## STAFF HEARING OFFICER STAFF REPORT

**REPORT DATE:** June 23, 2010  
**AGENDA DATE:** June 30, 2010  
**PROJECT ADDRESS:** 1402 Grand Avenue & 860 Jimeno Road (MST2008-00402)

A Substantial Conformance Determination has been requested to allow for changes to the approved project conditions outlined in Staff Hearing Officer Resolution 046-09. Condition II.A.1 required a one-car carport be built and the applicant has revised project to include the construction of a 603 square foot detached two-car garage for 1402 Grand Avenue. The applicant has requested revisions to conditions II.A.2-5, which restricted the vehicular access on the lot to the minimum area needed to turn a vehicle around, with a condition for planters and boulders to restrict vehicular access. The applicant has requested the enlargement of the area identified as a turn around area and a guest parking space.

**SITE PLAN - WALLS, GARAGE & LANDSCAPING**

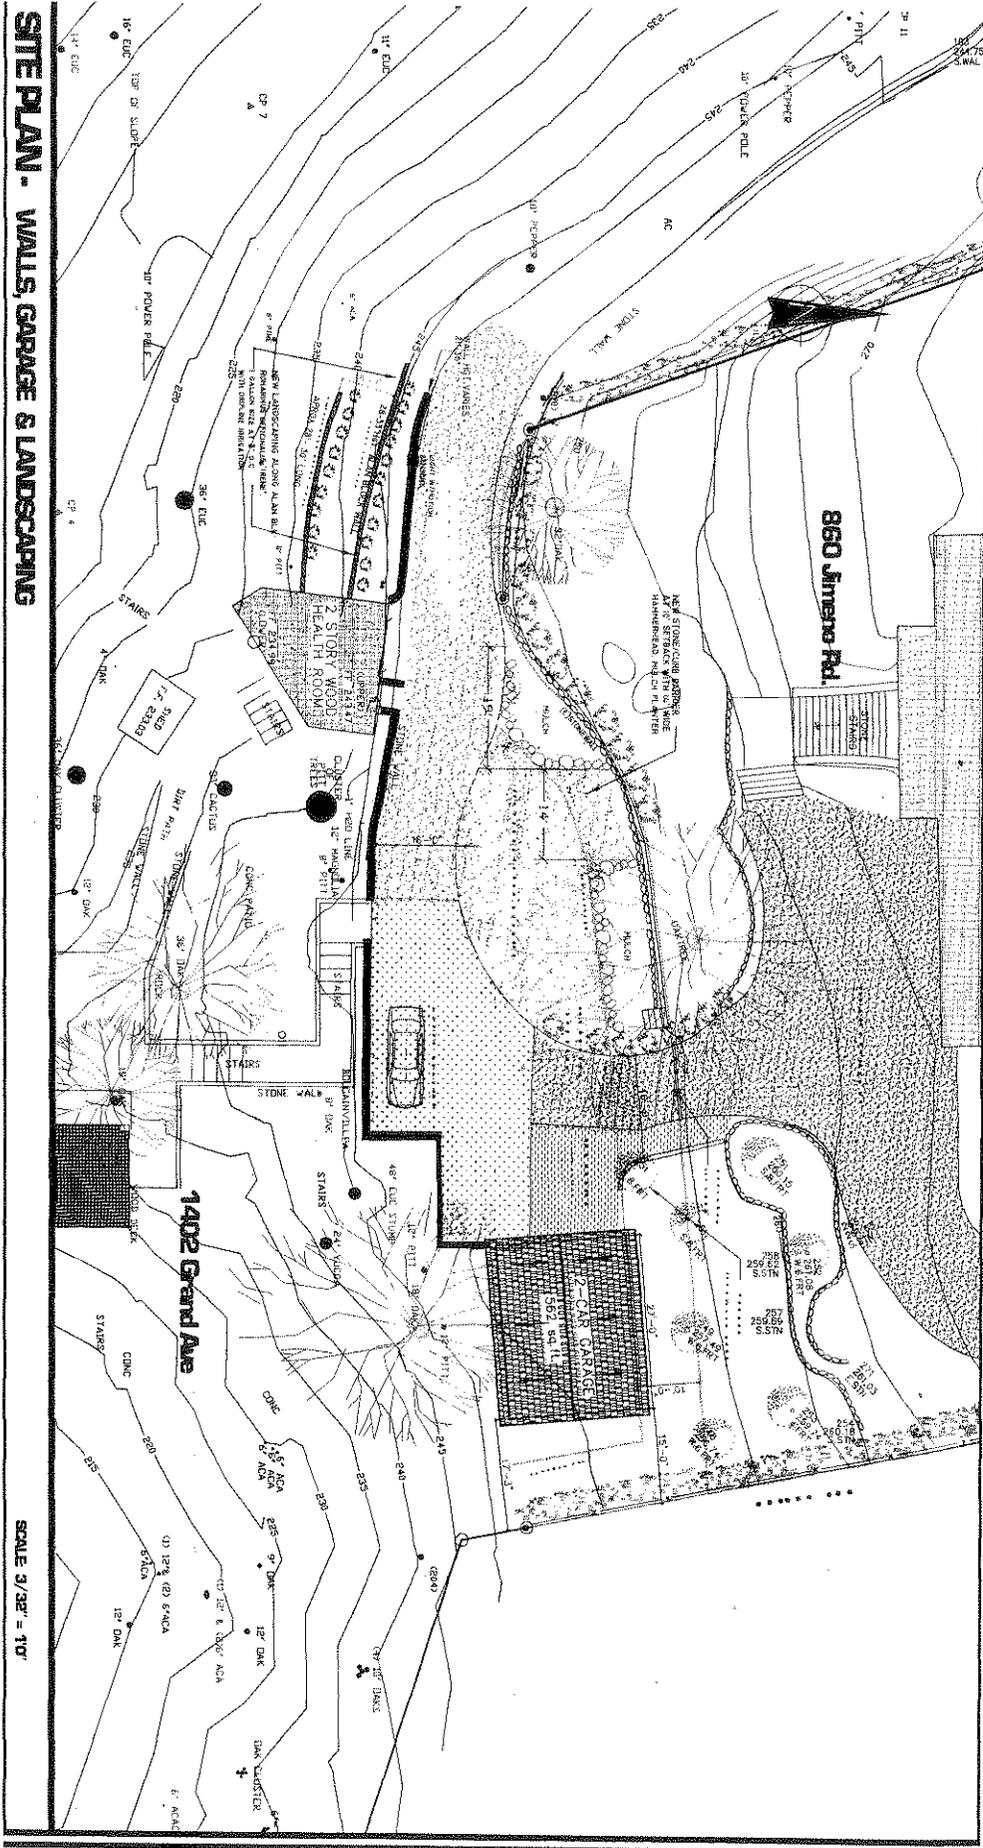
Therefore, our proposed revisions, as shown on the attached Exhibit A, would include the addition of guest parking spaces outside the setback (provided they do not interfere with the turnaround), elimination of the small tree in the triangle, as the arborist felt this competed with the oak, preservation of the 10 foot setback area with a stone/curb border, and the addition of a 14 foot wide hammerhead cutout into the setback area to allow vehicles to turn around for exiting the property. The 10 foot setback area, including the triangle, would be covered with mulch/bark and landscaped in a manner recommended by the arborist to not interfere with the oak.

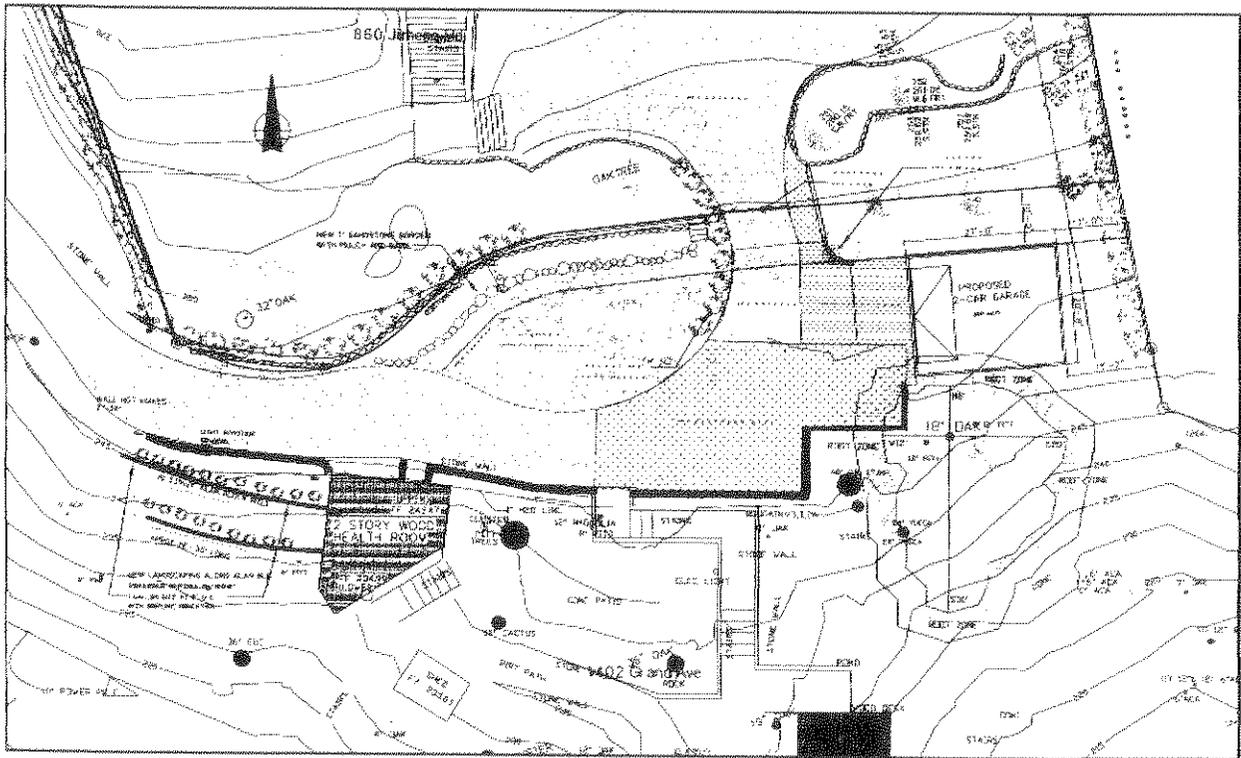
The Critical Root Zone (CRZ) of the tree is represented by the area within the dripline plus 5', is shown on the attached site plan section along with the outline of the proposed garage. The configuration of the garage outline overlaps the CRZ for a maximum of 3' along an 18' section.

I conclude that the area intruded upon by the garage foundation excavation is of such a small fraction of the total CRZ that the tree's health will not be affected.
